DEVELOPMENT REVIEW COMMITTEE (DRC) COMMENT REPORT

Project Name: Floval Oil Corp / 1075 W. Sunrise Blvd Gas Station

Case Number: R15041

Request: Site Plan Level II Review: Gas Station / Convenience Store and Car Wash

PROPOSED SITE PLAN

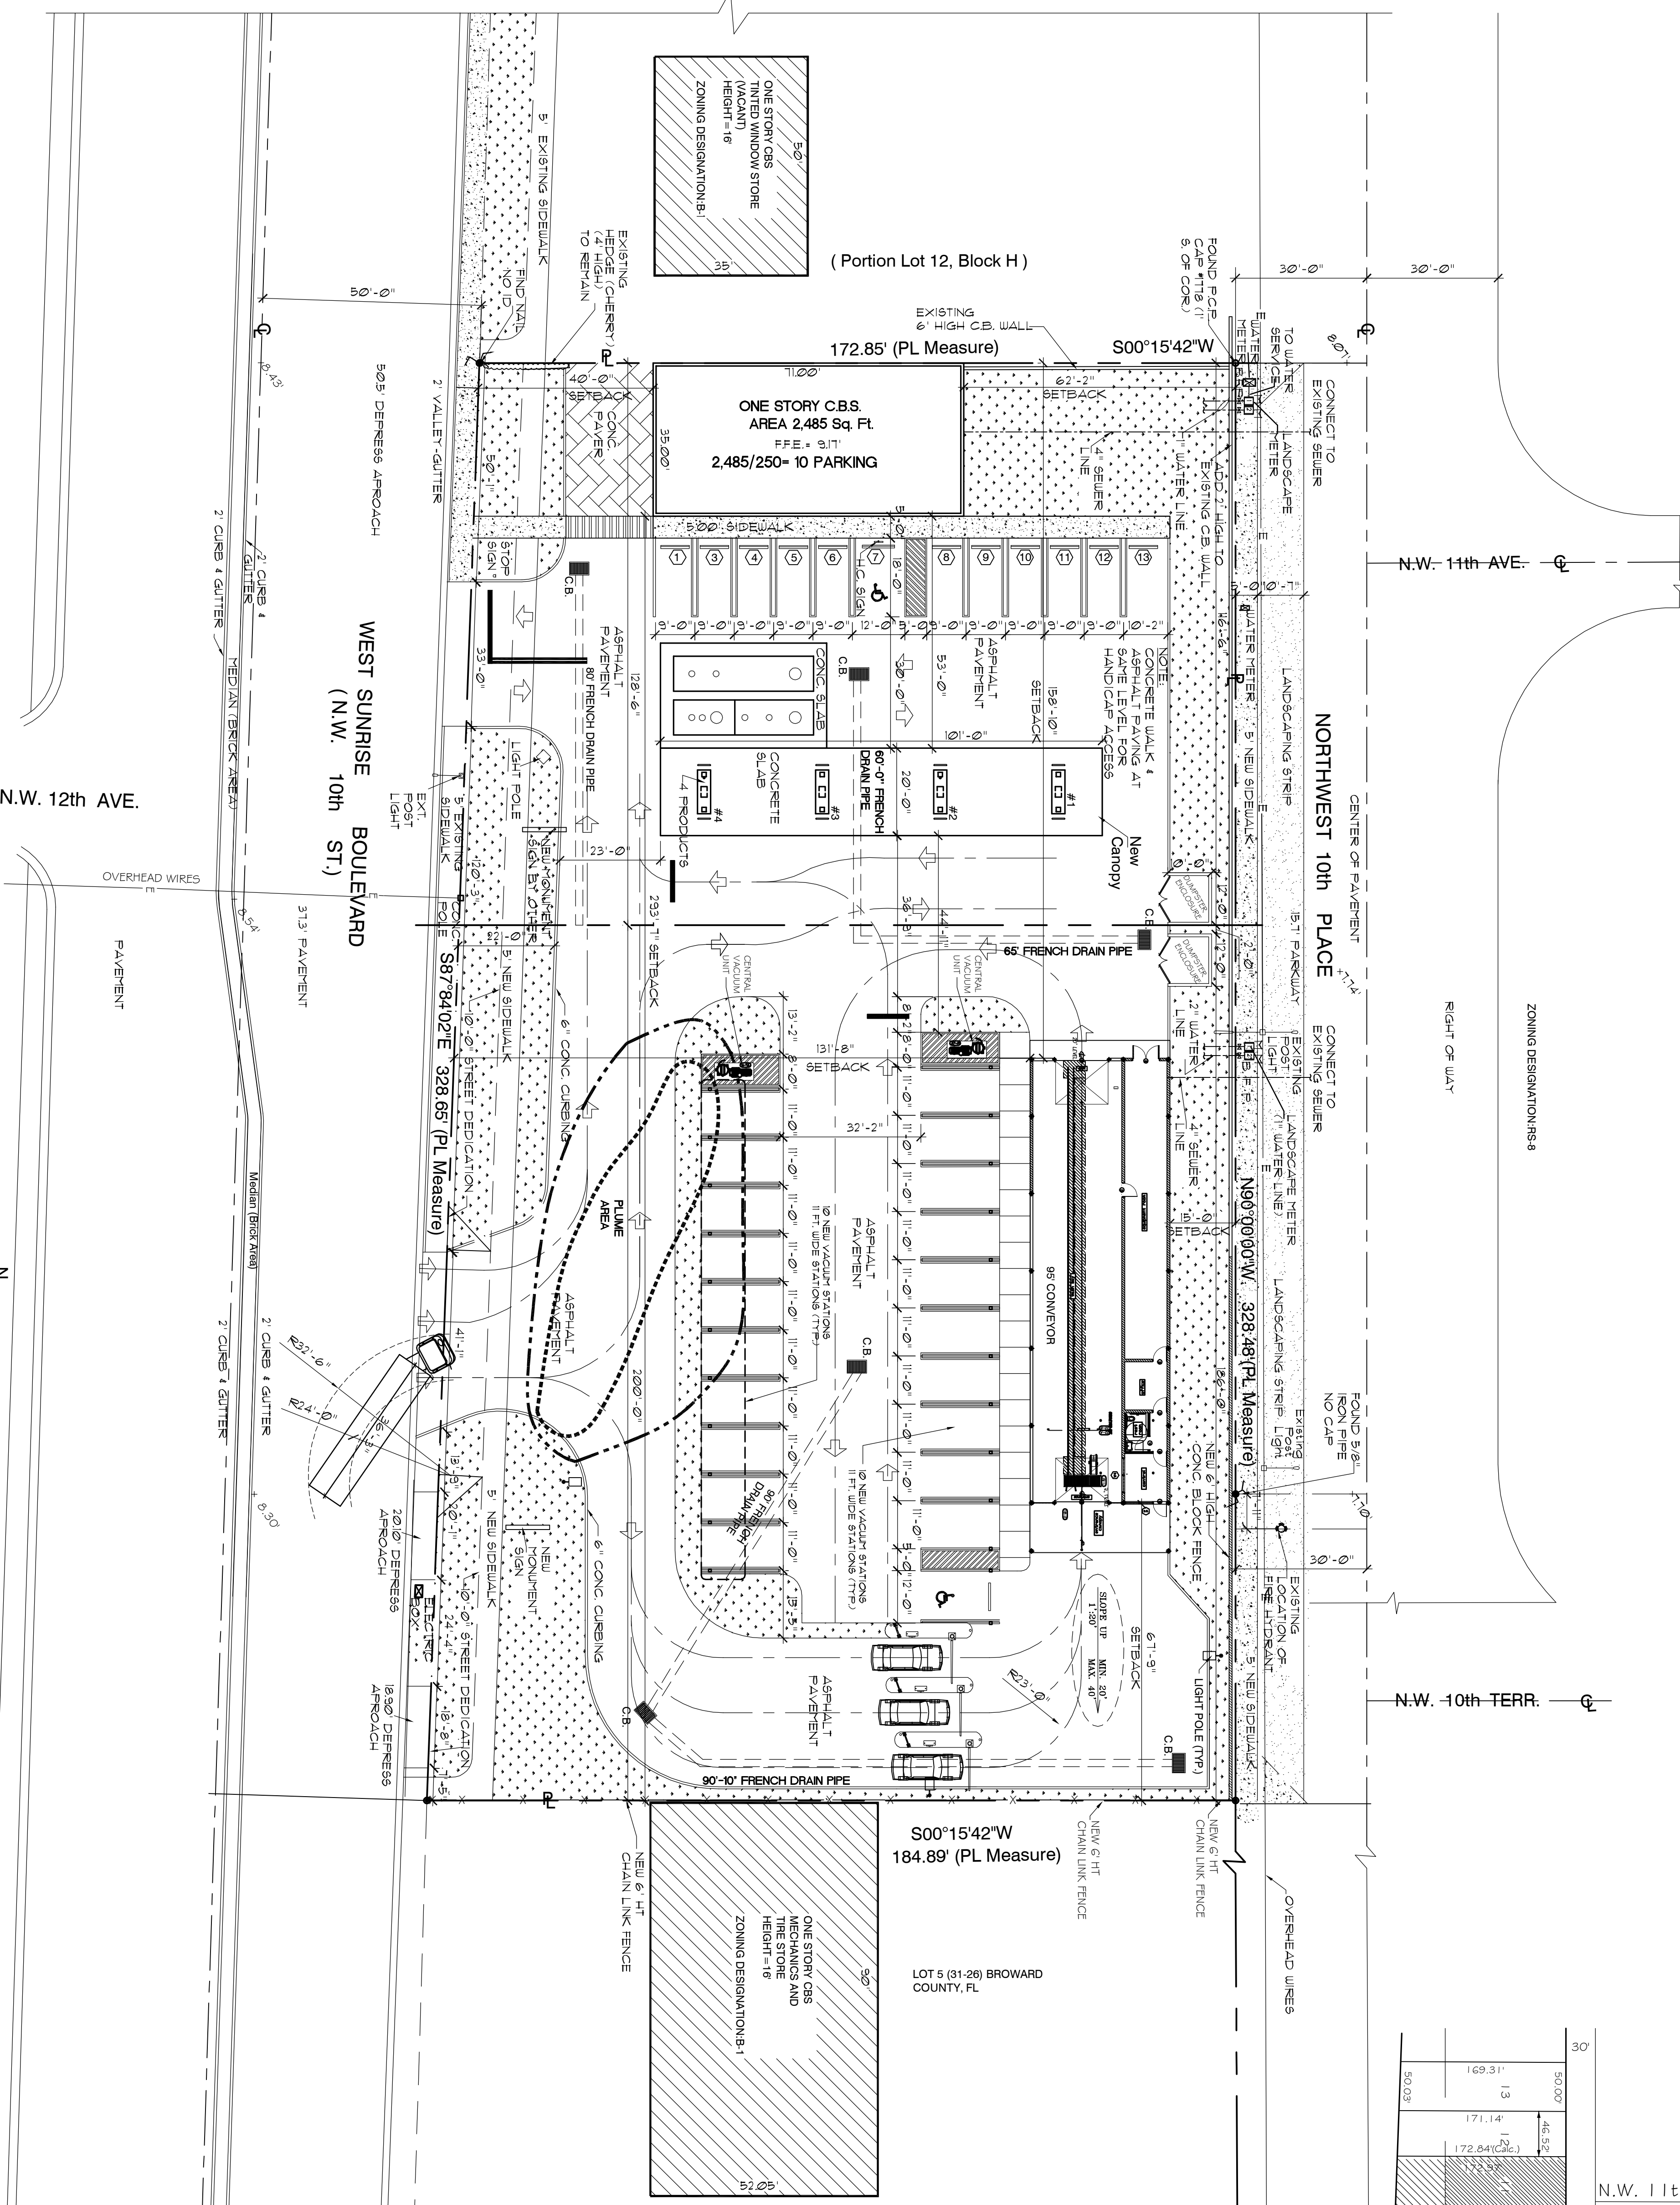
7. Proposed Site Plan – Discuss location of existing sidewalk (along SR 838 / W. Sunrise Blvd.) and driveway shown on adjacent property to the west, which doesn't appear to match existing conditions.

9. Coordinate proposed SR 838 / W. Sunrise Blvd. driveway locations, widths, and sight triangles with Florida DOT. Consider minimizing width of driveways and discuss one way in and out site circulation (including signage), but allowing enough driveway width for semi-trailer truck turning radii and access. Discuss why the semi-trailer truck template is shown turning from the W. Sunrise Blvd. middle westbound travel lane (Sheet 1).

13. Dimension all parking areas, including drive isle widths, turning radii, and parking stalls.
14. Discuss the purpose of the Concrete Paver area, located just south (W. Sunrise Blvd. side) of Gas Station building.

1. It appears that there is additional pavement at east driveway entrance. Please illustrate truck turning template on plans, and remove excess pavement at entrance.

2. Remove the sidewalk to the south along Sunrise.
3. Parking rows are to begin and end with landscaped islands containing canopy trees. Illustrate this on plans.

- g. Provide renderings of the building and canopy similar to those provided for the car wash.
5. Effort should be made to reduce the width of the ingress and egress to the site in order to eliminate pedestrian conflict points. The 41 foot wide, three lane ingress proposed at the eastern part of the site appears excessive to accommodate a one-way entrance. As currently indicated on the site plan, the fuel truck needs only one to two lanes to enter the site.

10. Re-evaluate the dimensions provided in the plan. The scale of certain items seems off – especially the semi-truck shown in comparison to parking spaces.

CONV. STORE FRONT(SOUTH) ELEVATION

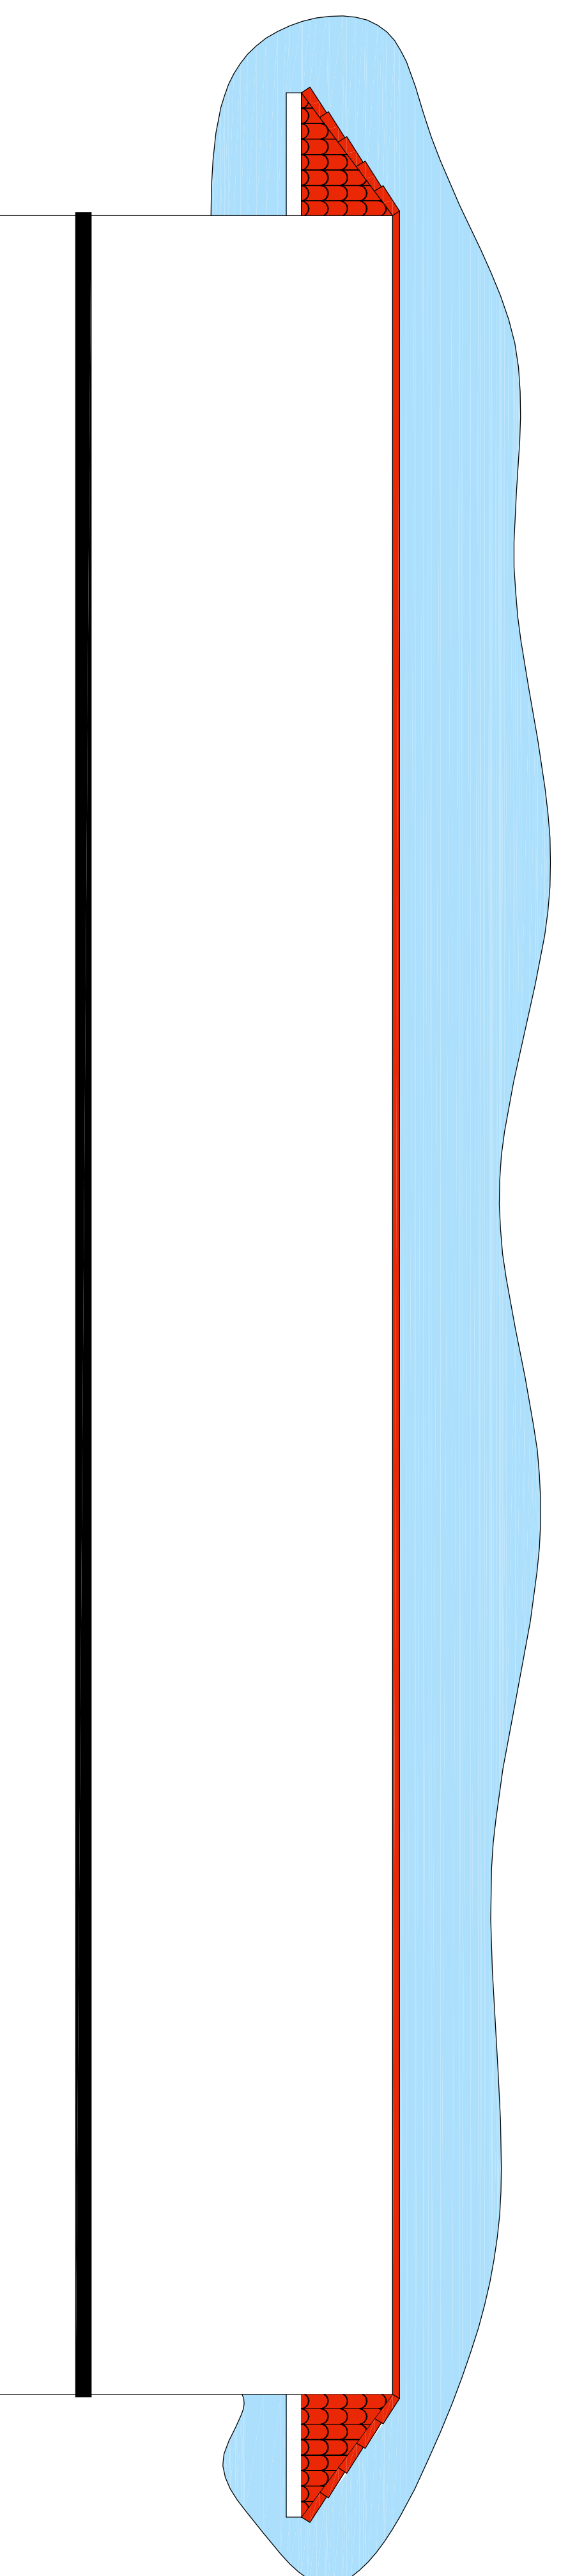
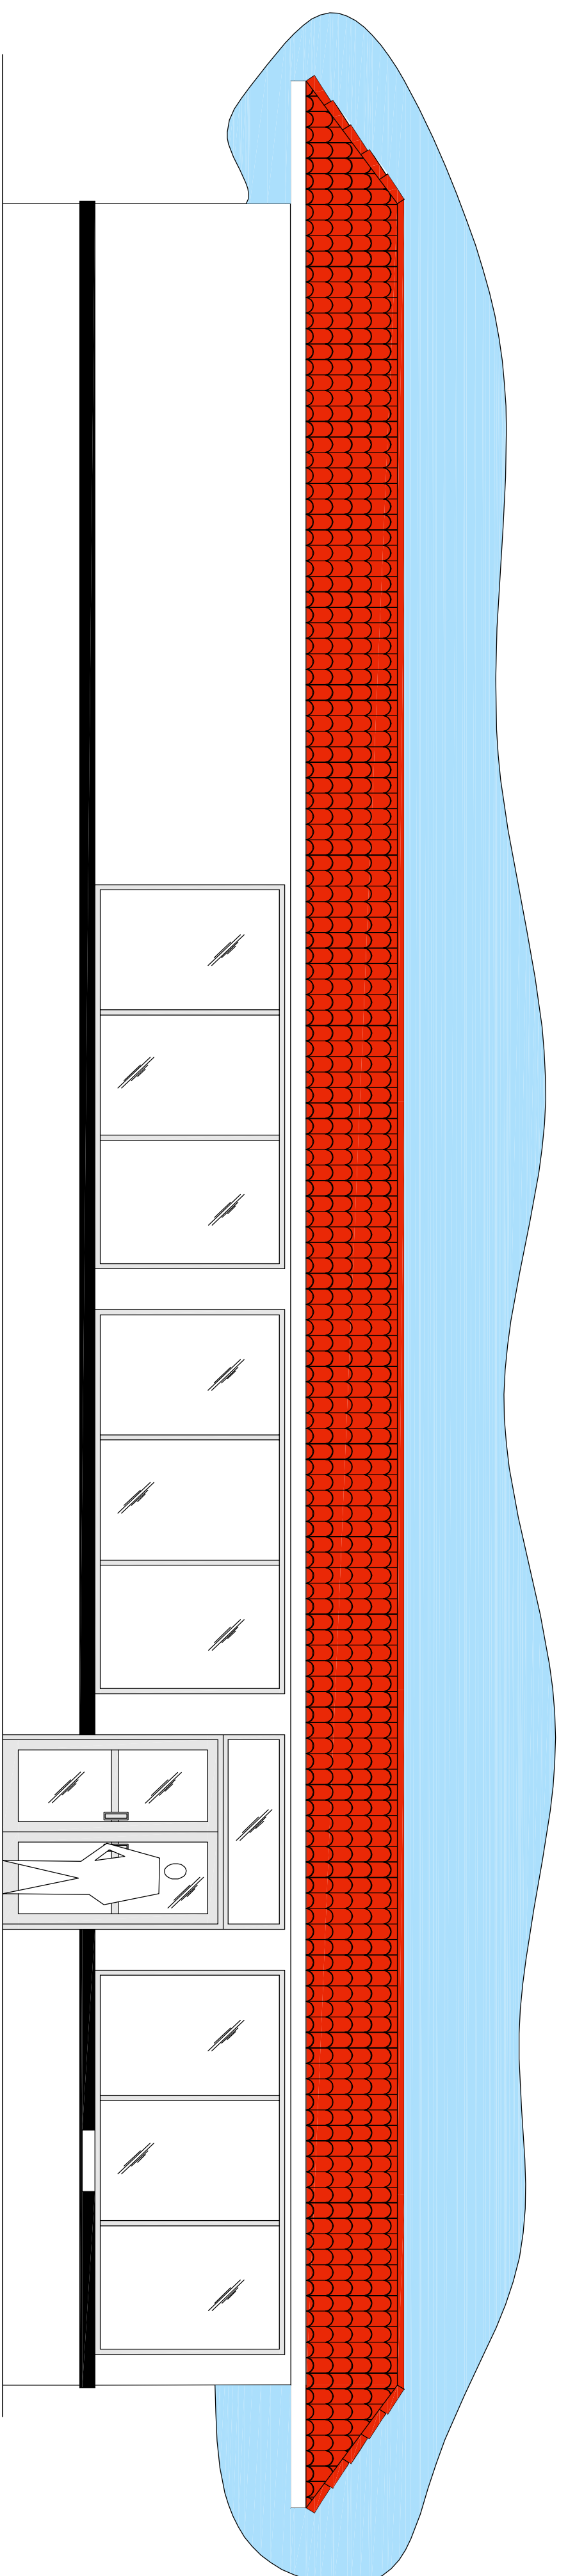
16. The cardinal directions for the building façades on pages 6, 7, and C-1 are mislabeled.
17. Incorporate bicycle parking into the site plan near the entrance of the convenience store.
